**Addendum No. 3**  
Page 1 of 23

**TO:** Prospective Respondents  
**SUBJECT:** Addendum No. 3  
**PROJECT NAME:** Romeoville Campus Expansion Bid Release 2  
**JJC PROJECT NO.:** B15028

This Addendum forms a part of the Bidding and Contract Documents and modifies the original bidding document as posted on the JJC website. Acknowledge receipt of this addendum in the space provided on the Bid Form. FAILURE TO DO SO MAY SUBJECT BIDDER TO DISQUALIFICATION.

A793.02

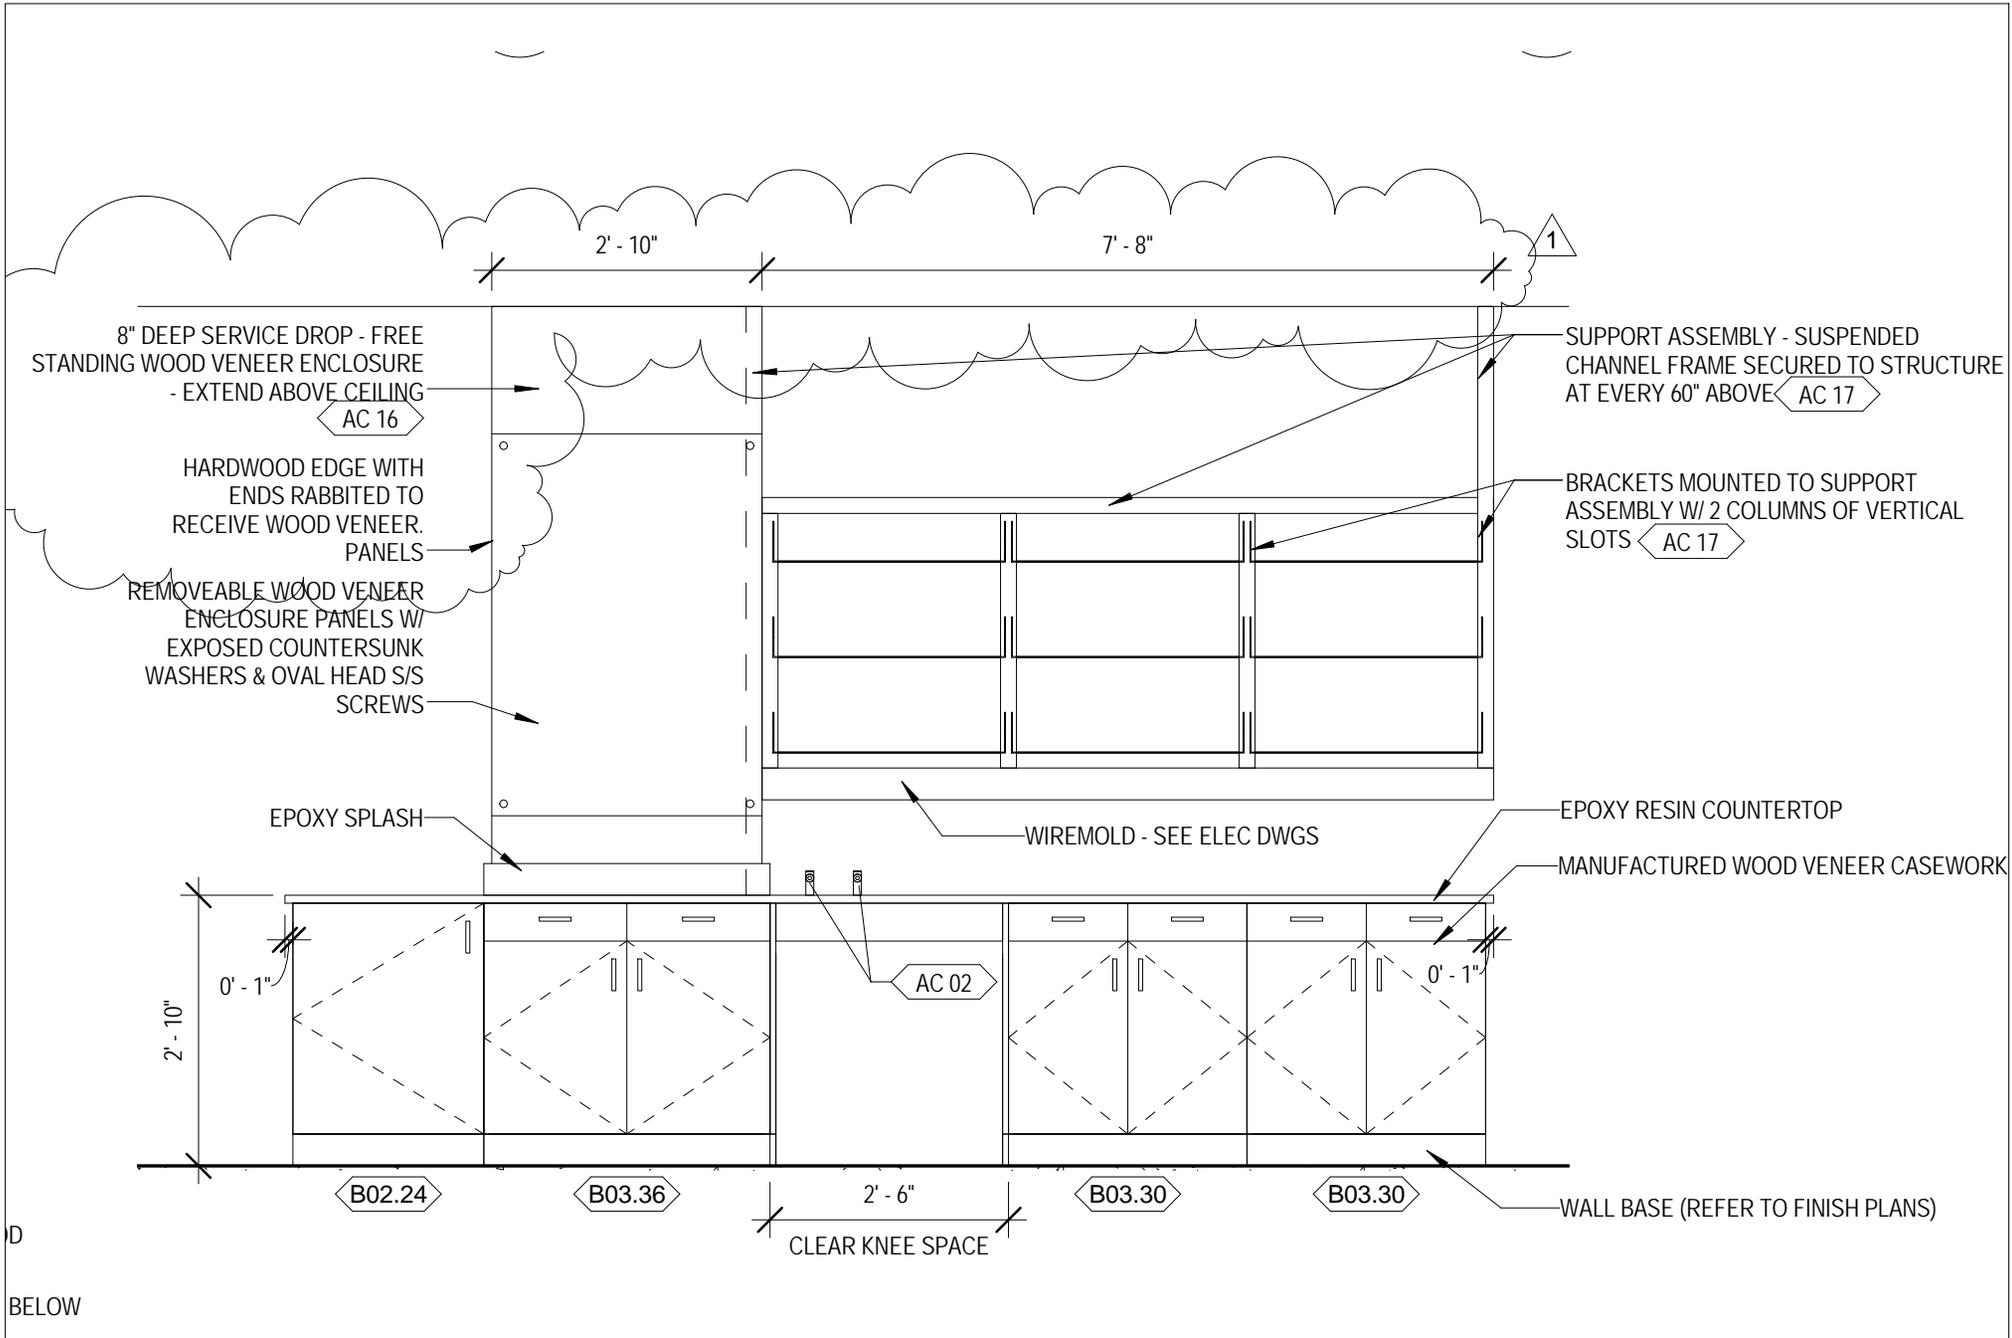
- O. Sheet A7.93:
- 1) **REVISE** detail 9 per attached **sketch A793.01**.
  - 2) **REVISE** detail 7 per attached **sketch A793.02**.
- P. All Science Labs Sheets – Lab Casework General Notes:

A904.01

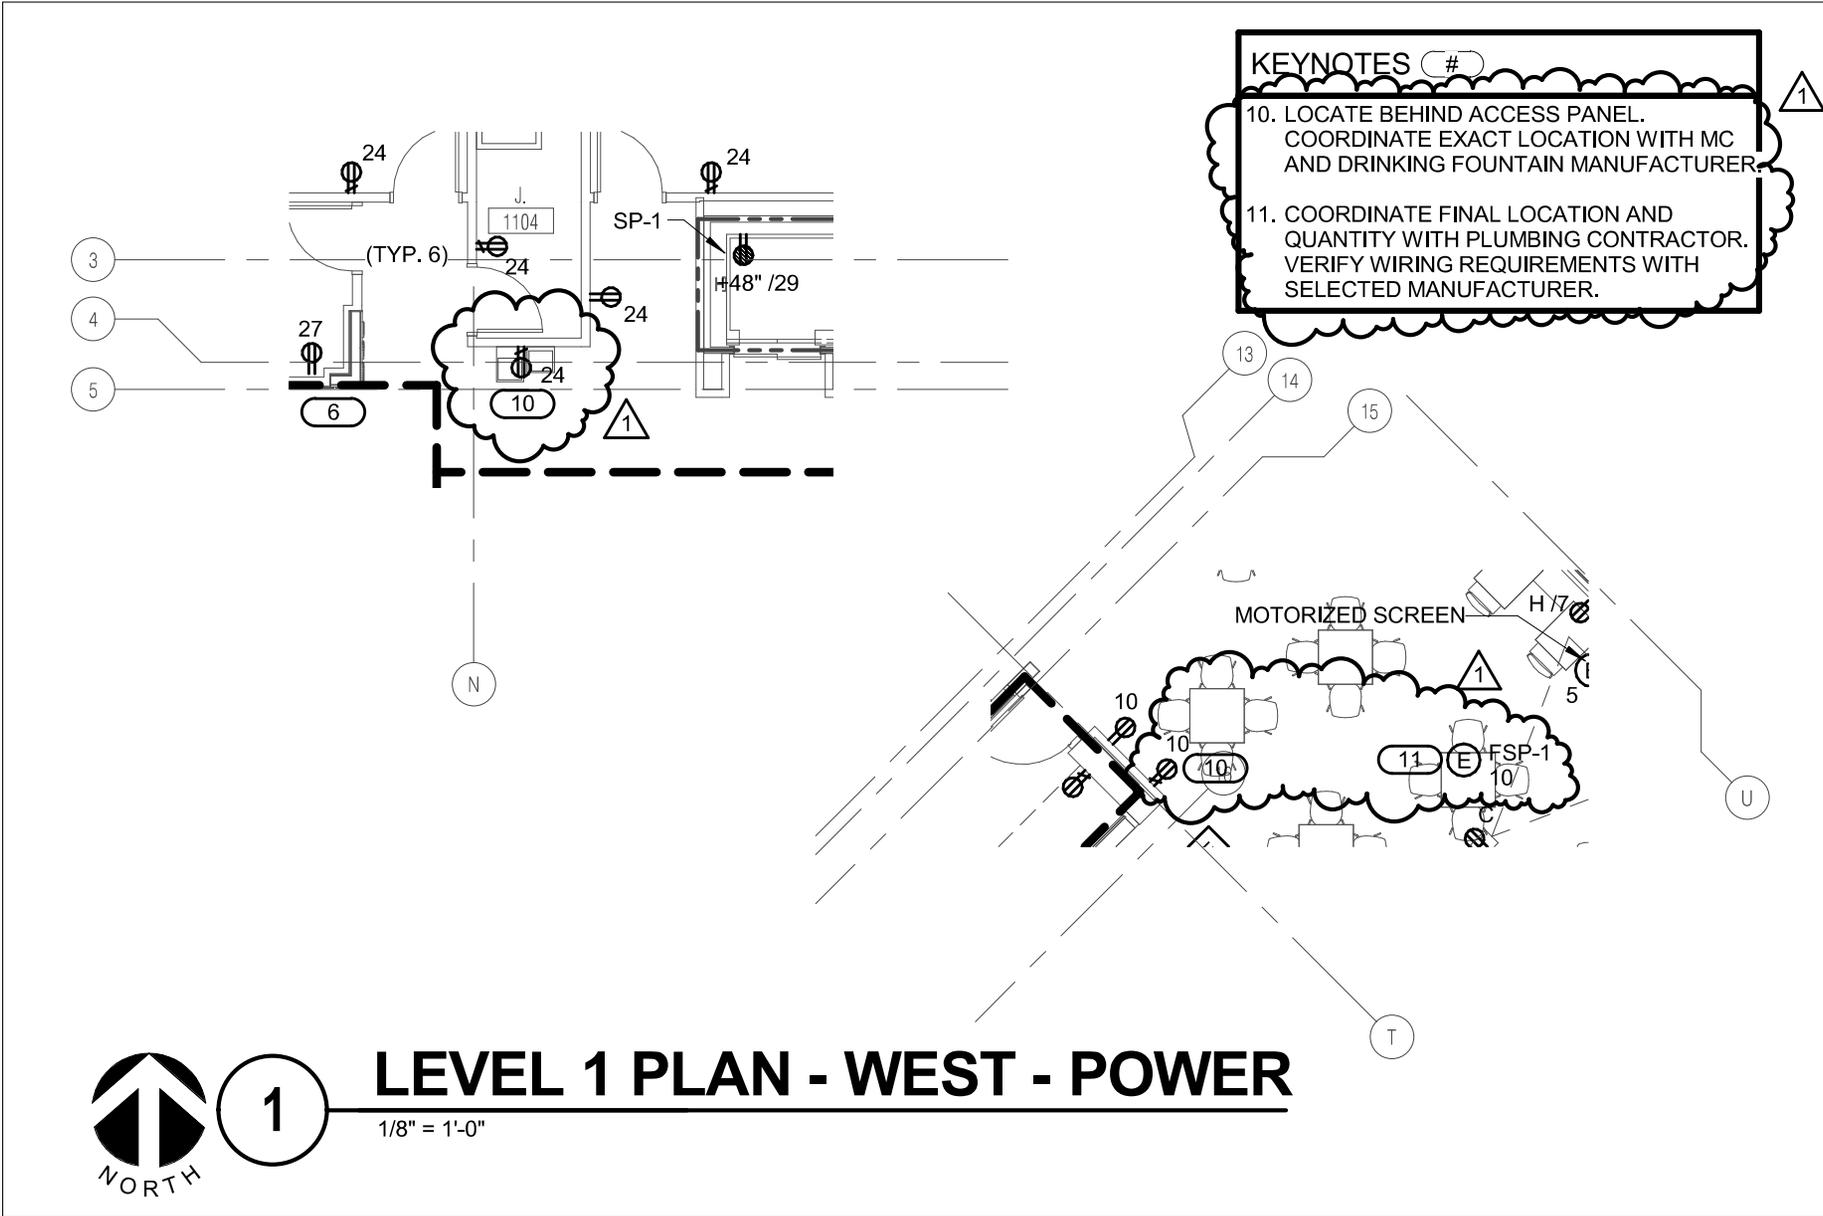
- R. Sheet A8.13: **REVISE** detail 15 per attached **sketch A813.01**.
- S. Sheet A8.14: **REVISE** detail 1 note to read “TACK AND DISPLAY STRIP”
- T. Sheet A9.04: **REVISE** detail 10 per attached **sketch A904.01**.

ADDENDUM 3  
**E230.10**

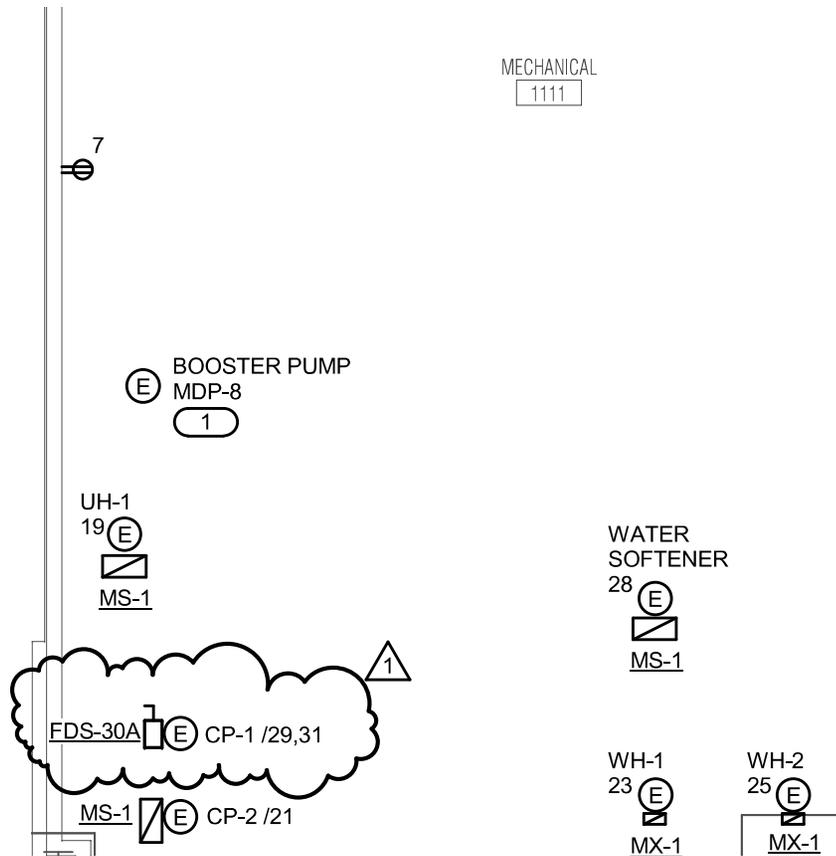
- H. Drawing E2.30:
  - a. **MODIFY** the three (3) PV-COMB so keynote #2 is attached to these equipment.
  - b. **MODIFY** keynote #2 to read: SELF-SUPPORT DISCONNECT AND COMBINER BOX WITH STEEL CHANNELS. PRIVE AND PAINT STEEL CHANNELS.

M111.01

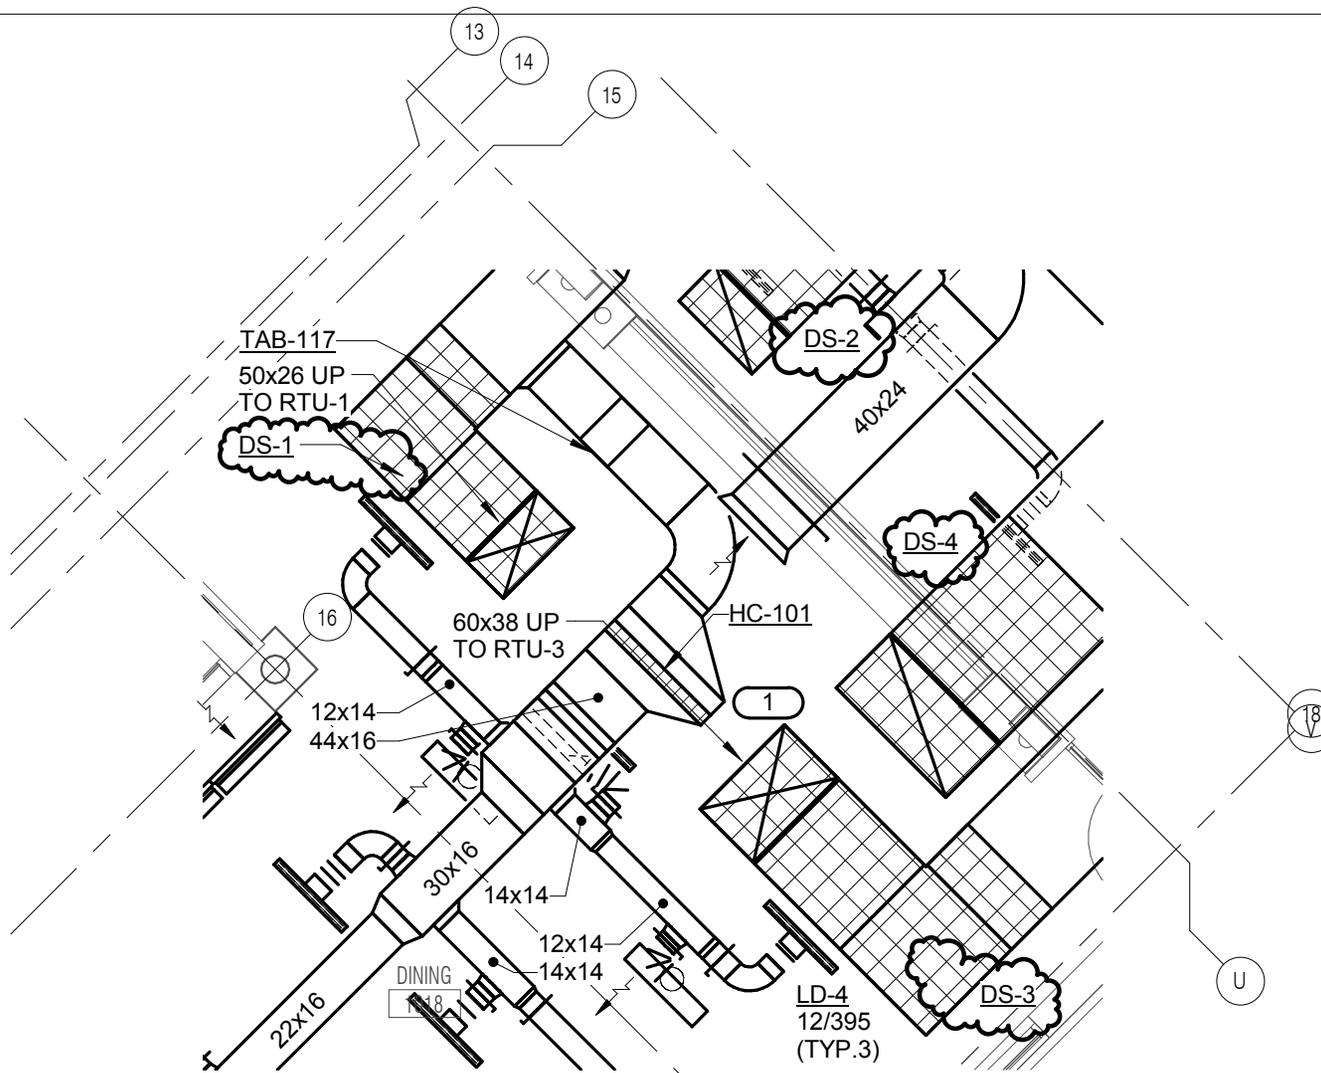
- 1) **ADD** new return grille (RG-1) for Vestibule 1109. **MODIFY** downstream duct size associated with TAB-107 serving the Office 1003. Refer to M111.01 for more information.
- 2) **ADD** tags for duct silencers associated with ductwork of RTU-1 and RTU-3. Refer to M111.02 for more information.
- 3) **MODIFY** supply diffuser to 8" inlet size and **REVISE** supply airflow to 100 CFM for Dry Storage -1016A.
- 4) **MODIFY** supply diffusers (qty. 6) to 12" inlet size and **REVISE** supply airflow of five diffusers to 470 CFM and one diffuser to 475 CFM in Food Prep -1016.
- 5) **ADD** new TAB-141, associated ductwork, supply & transfer grilles to serve ELEVATOR CONTROL CLOSET 1113. Refer to M111.03 for more information.

M112.01

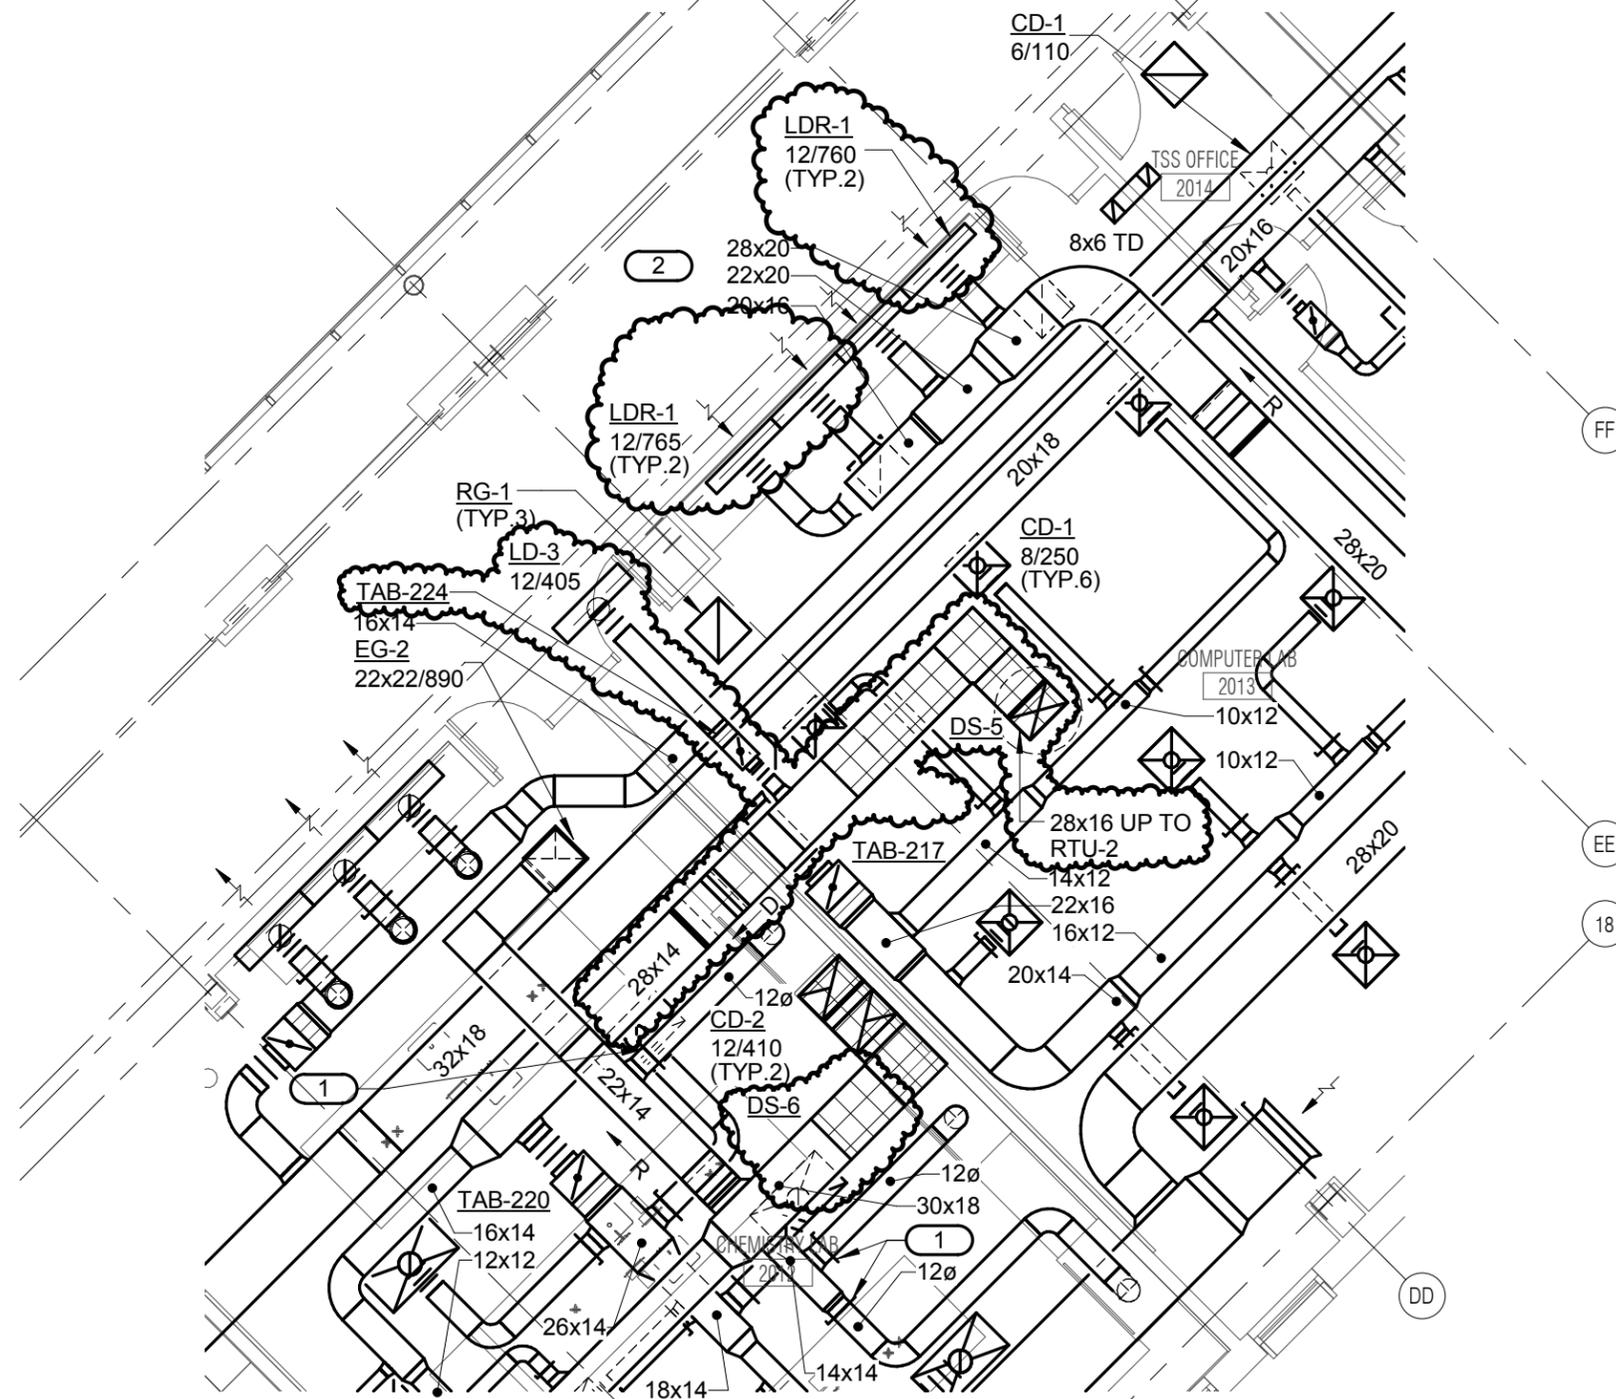
- 1) **ADD** new return grilles (RG-1) for Vestibule 1100. Refer to M112.01 for more information.
- 2) **REVISE** return airflow of three return grilles to 880 CFM & one return grille to 870 cfm for Corridor which is south of Vestibule 1100.
- 3) **BALANCE** return airflow damper to 16230 CFM for RTU-3 return bell mouth which is located above ceiling of Student Meeting space 1021.
- 4) **BALANCE** return airflow damper to 2905 CFM for RTU-2 return Bell Mouth which is located above ceiling of Student Meeting space 1021.

M132.01

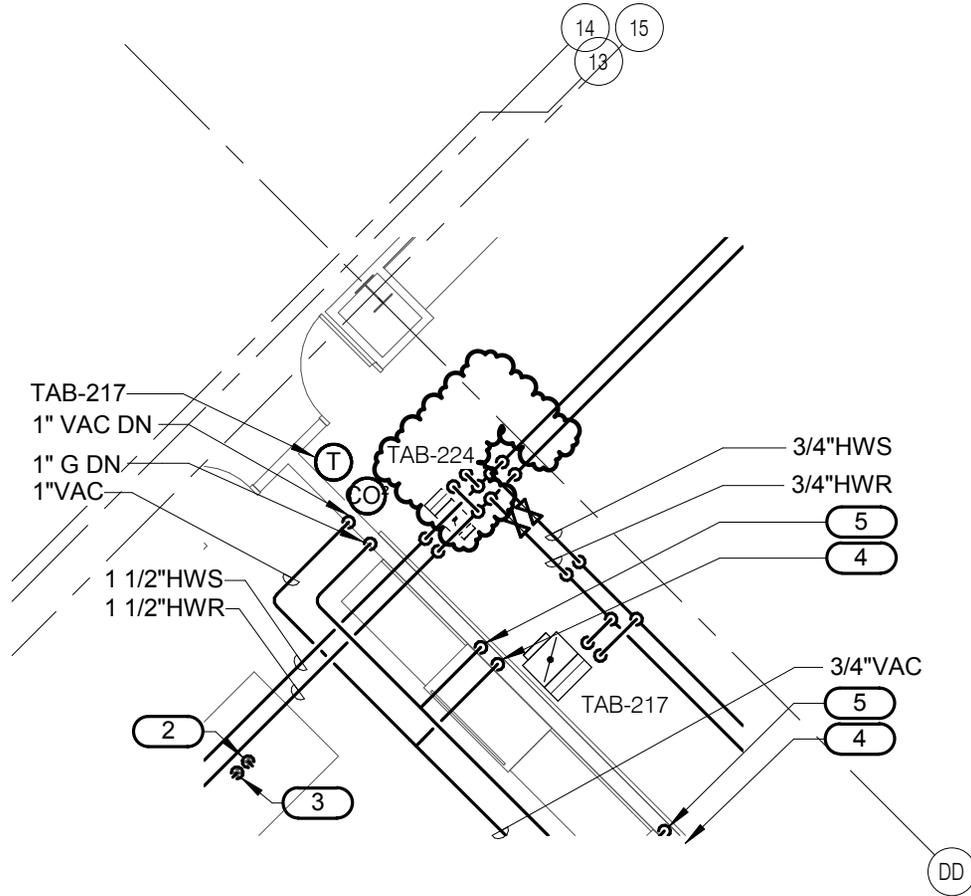
- 1) **REVISE** size of RTU-2 and **ADD** new note for RTU-2 on Roof plan - East. Refer to M132.01 for more information.
